CZECH SPORT AIRCRAFT	<h1>SERVICE BULLETIN</h1>	Czech Sport Aircraft a.s. Na Záhonech 212, 686 04 Kunovice Czech Republic office@czechsportaircraft.com	
		No.: SB-CR-042	Rev.: 2
		Date: 2018-05-14	Date: 2019-01-15
Page: 1 of 14

MODEL AFFECTED:	PS-28 Cruiser and SportCruiser / PiperSport aircraft under EASA regulation
SUBJECT:	Landing Light Replacement (original TrailTech 4213-SX for TrailTech D112-SX)
AIRCRAFT AFFECTED:	All aircraft according to section "MODEL AFFECTED", as applicable
COMPLIANCE:	Apply this Service Bulletin when replacement of the original Trail Tech 4213-SX landing light is needed

Figure 1 – Dismounting of the Original landing light Trail Tech 4213-SX

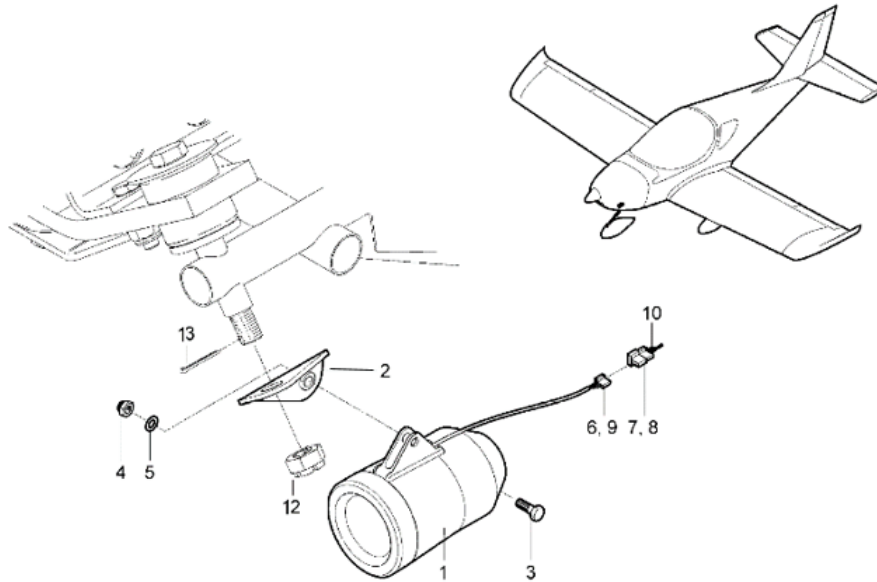
- 1.7 Disconnect the Original landing light from the aircraft wiring system - cable with the connector (6, 9) from the wiring (7, 8, 10), see **Chyba! Nenalezen zdroj odkazů.** above.

- 1.8 Remove the Original landing light (1) with bracket (2) from the engine mount.
- 1.9 Screw back the castle nut (12) and secure with the new cotter pin (13). To eliminate the slackness use the washer (33).

Figure 2 - Mounting of the New landing light Trail Tech D112-SX

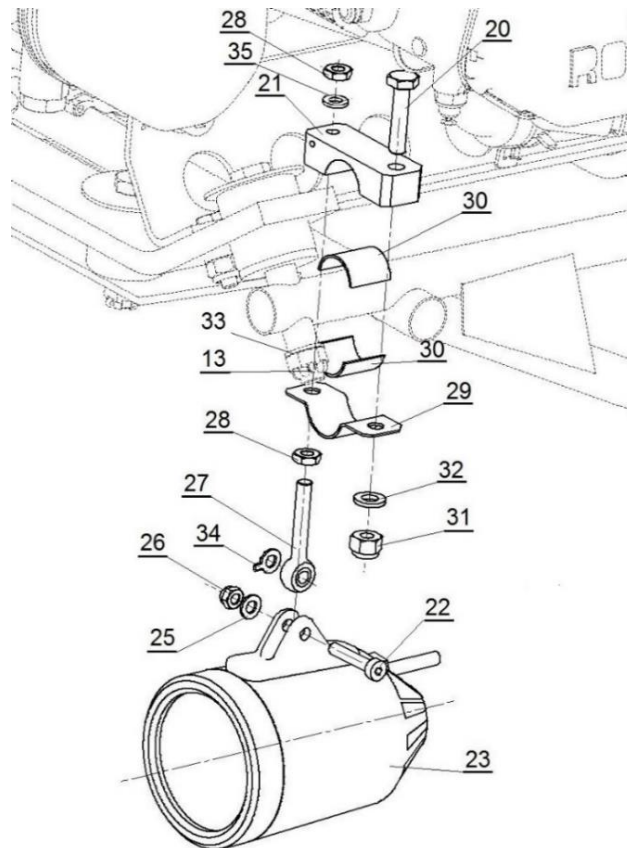
- 1.10 Install the New landing light (23) with the new holder (21, 29, 30) supplied by the Czech Sport Aircraft using connecting parts (20, 31, 32, 22, 25, 26, 27, 28, 35), see Figure 2.

Remember that the New landing light can only be operated at 1250 Lumens, otherwise there might be a risk of overloading the 12V DC supply.

Therefore, ensure that the +12VDC voltage is connected to the red and - (0 V) to the black wire.

- 1.11 If the gap between the light mounting (23) and the threaded eye (27) on the screw (22) is 0,5 mm or more, insert the washer (34) between the light mounting and the threaded eye. Tighten the screw (22) firmly.
- 1.12 Interconnect the airplane connector (8) with the landing light connector (24), see **Chyba! Nenalezen zdroj odkazů.** and **Chyba! Nenalezen zdroj odkazů.** above.
- 1.13 Install the engine lower cowling and check the landing light position – it must be adjusted so that the optical axis of the landing light passes through the middle of the engine lower cowling opening, see **Chyba! Nenalezen zdroj odkazů.** and **Chyba! Nenalezen zdroj odkazů.** Use the parts (21, 29, 30) for adjustment.

Figure 3 – The New landing light position adjustment

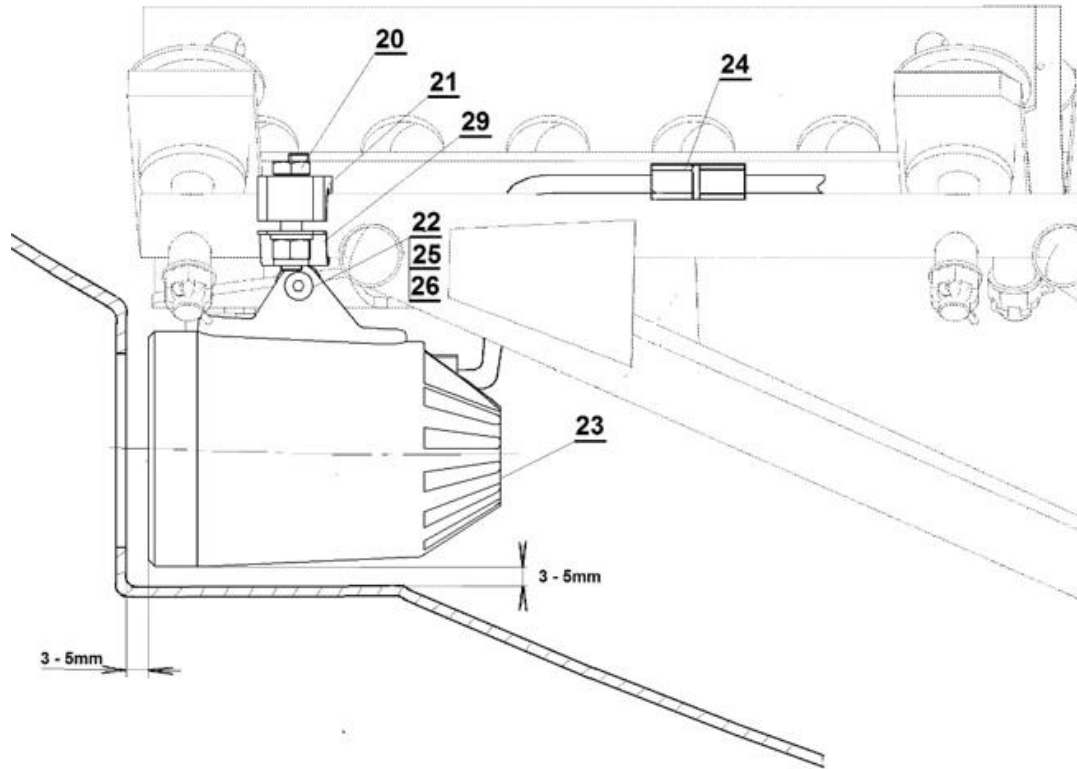
Note: To reach the adjustment parts (21, 29, 30), the engine lower cowling has to be removed first. To check the adjustment, the engine lower cowling has to be installed first.

- 1.14 Once a correct landing light position is set, remove the engine lower cowling and secure the adjustment by tightening the nut (28) and connecting parts (20, 31, 32).
- 1.15 Find the circuit / switch circuit breaker of the landing light (LDG L) on the instrument panel (see the CR-MM-1-0-00, latest revision) and check the rating. The range of 3A is correct current rating for the New landing light circuit / switch circuit breaker rating.

Figure 5 - The LDG L MS3320-x circuit breaker. Placed on the right instrument panel

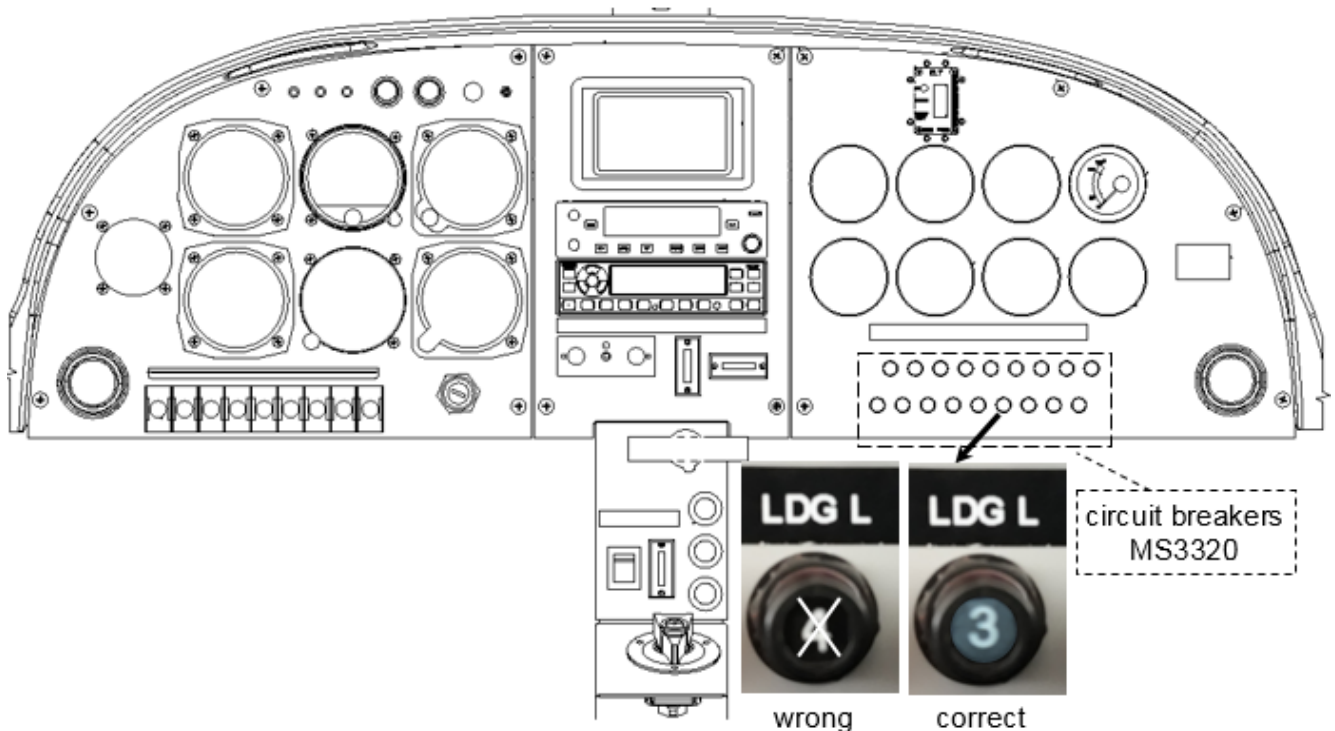
The MS3320 LDG L circuit breaker is installed on the right instrument panel, see Figure 5, The circuit breaker is marked "LDG L". Replacement of the circuit breaker has no effect on mass and CG of the airplane.

- 2.1 Determine the LDG L circuit breaker (text "LDG L") on the right instrument panel, see Figure 5.
- 2.2 Secure that the MASTER BATT switch is turned off and disconnect the battery terminals, see the CR-MM-1-0-00, point 11.3.2, latest revision.
- 2.3 Remove the screws (2) with the washers (3) from the main supply bus (4) of all the circuit breakers, see Figure 6.

Figure 6 - Connection of the MS3320-x circuit-breakers to the main supply bus

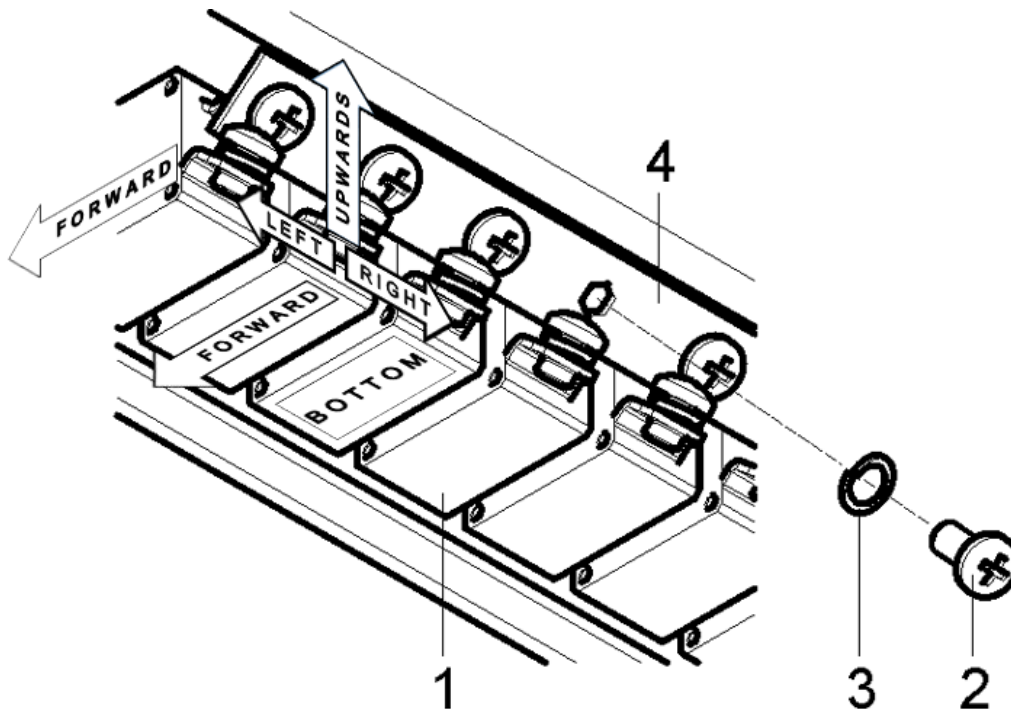
- 2.4 Remove the main supply bus (4) from the all circuit breakers (1) on the right instrument panel, see Figure 6.

Figure 7 - MS3320-x circuit breaker removal / installation

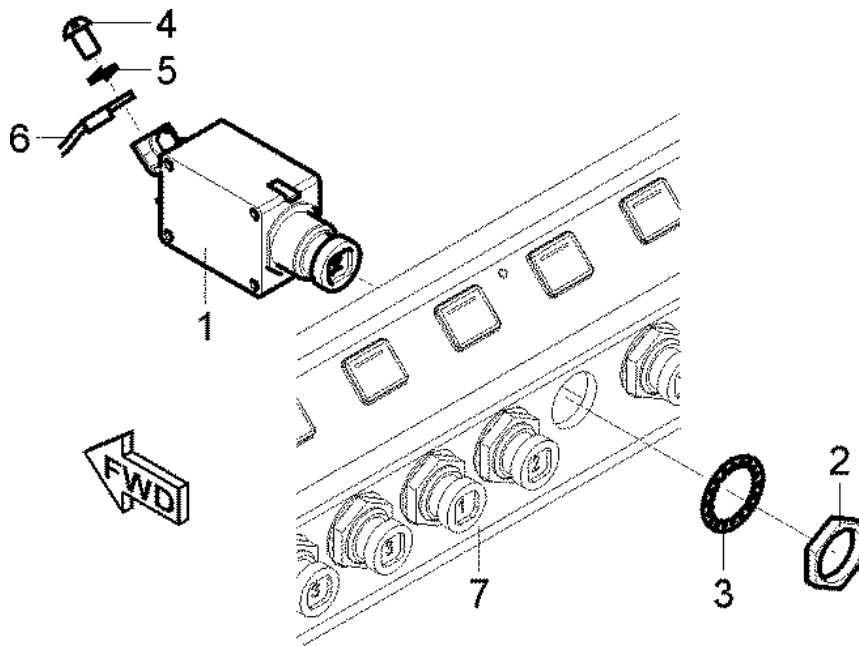
- 2.5 Release the screw (4) with the washer (5) and disconnect the cable (6) from the LDG L circuit breaker, see Figure 7.
- 2.6 Unscrew the nut (2), the washer (3) and remove the original LDG L circuit breaker (1), see Figure 7. To unscrew the nut (2) use the ½ inch wrench.

- 2.7 Use the new LDG L circuit breaker from the replacement package (MS3320-3, current range of 3A), see Figure 5. Insert the circuit breaker in the right instrument panel and fix using the nut (2) with the washer (3), see Figure 7.

- 2.8 Connect the cable (6) using the screw (4) with the washer (5), see Figure 7.
- 2.9 Fix the main supply bus (4) back to the all circuit breakers using the screws (2) with the washers (3), see Figure 6.

Figure 8 - The LDG L W31X2M1G-x switch circuit breaker. Placed on the left instrument panel

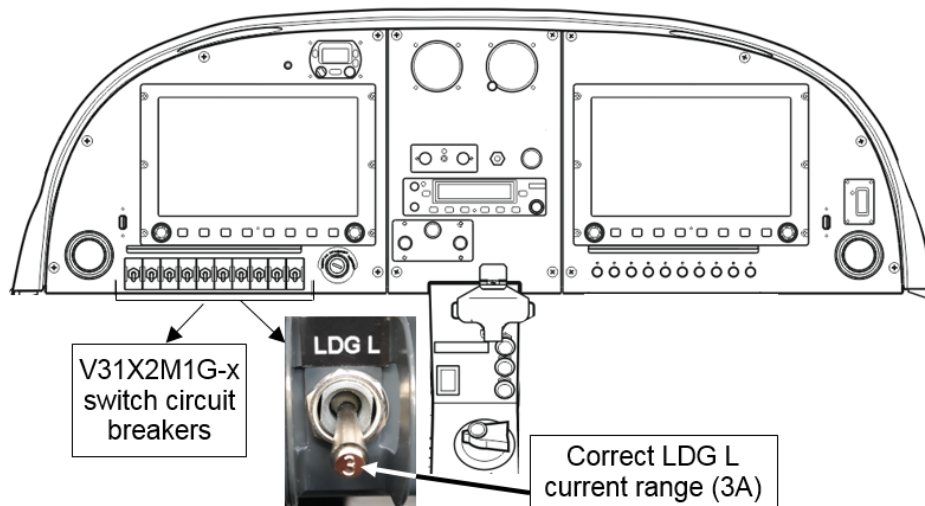
The W31X2M1G-x switch circuit breaker (marked “LDG L”) is placed on the left instrument panel. Replacement of the switch circuit breaker has no effect on mass and CG of the airplane.

- 3.1 Determine the LDG L switch circuit breaker (text “LDG L”) on the left instrument panel, see Figure 8.
- 3.2 Secure that the MASTER BATT switch is turned off and disconnect the battery terminals, see the CR-MM-1-0-00, point 11.3.2, latest revision.
- 3.3 Release the screws (2) with the washers (3) of all the switch circuit breakers and remove the main supply bus (4), see Figure 9.

Figure 9 - Connection the new LDG L W31X2M1G-3 switch circuit breaker to the main supply bus.

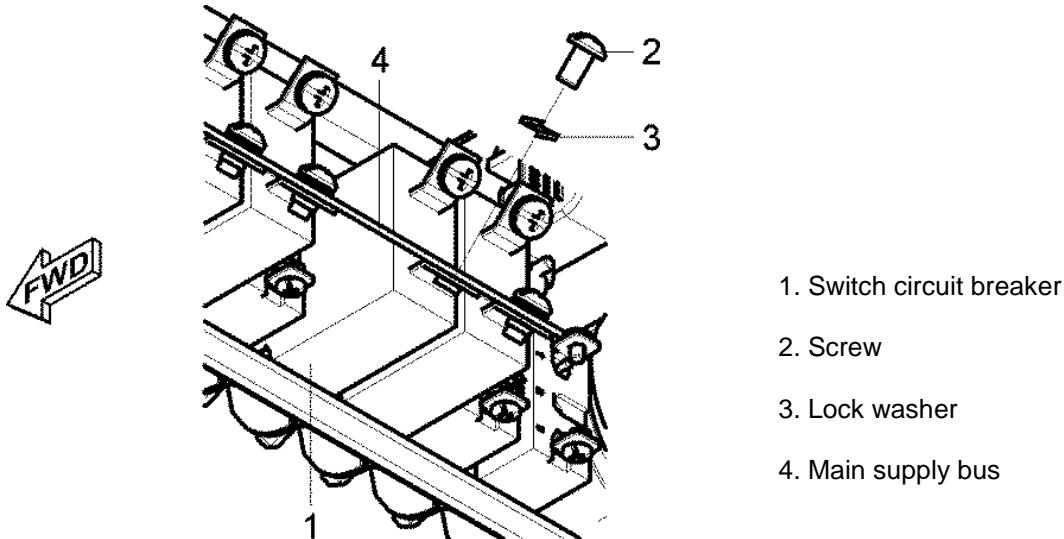
- 3.7 Use the screw (6) with the washer (7) and connect and fix the cable (8) to the new switch circuit breaker (1), see Figure 10.
 - 3.8 Fix the main supply bus (4) back to the all switch circuit breakers using the screws (2) with the washers (3), see Figure 9.

Figure 10 - W31X2M1G-x switch circuit breaker removal / installation

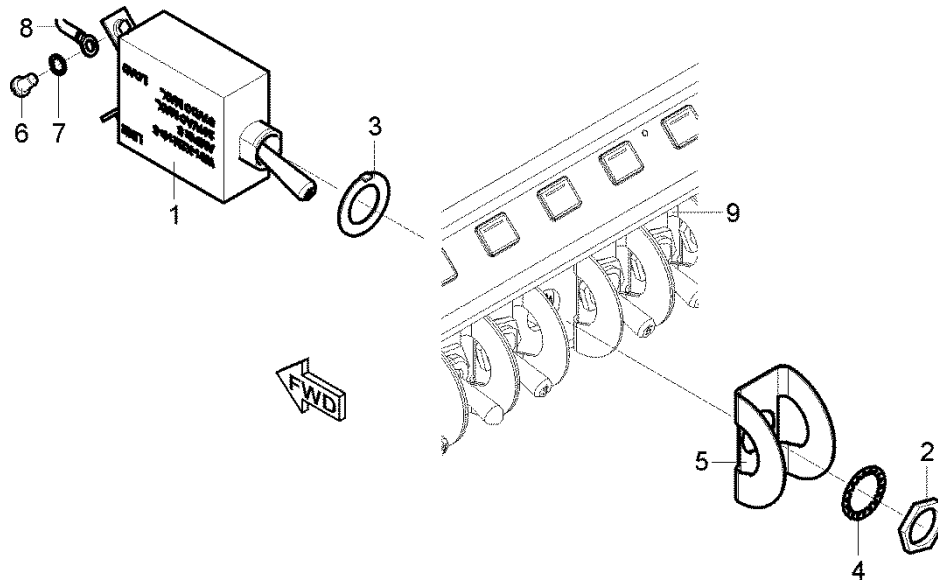
- 3.4 Remove the nut (2), the washers (3, 4) and cover (5) of the original LDG L switch circuit-breaker (1), see Figure 10.
 - 3.5 Remove the screw (6) with the washer (7), and disconnect the original LDG L switch circuit-breaker cable (8), see Figure 10. Remove the original LDG L switch circuit breaker (1).

- Note:** The new W31X2M1G-3 switch circuit breaker hardware; screws (6), nut (2), washers (3; 4; 7), see Figure 10, are included in the package.
- 3.6 Use the new W31X2M1G-3 LDG L switch circuit breaker (current range of 3A) from the replacement package and insert it in the left instrument panel instead of the original switch circuit bracket. Apply the cover (5) and fix the switch circuit breaker using the nut (2) with the washers (3, 4), see Figure 10.
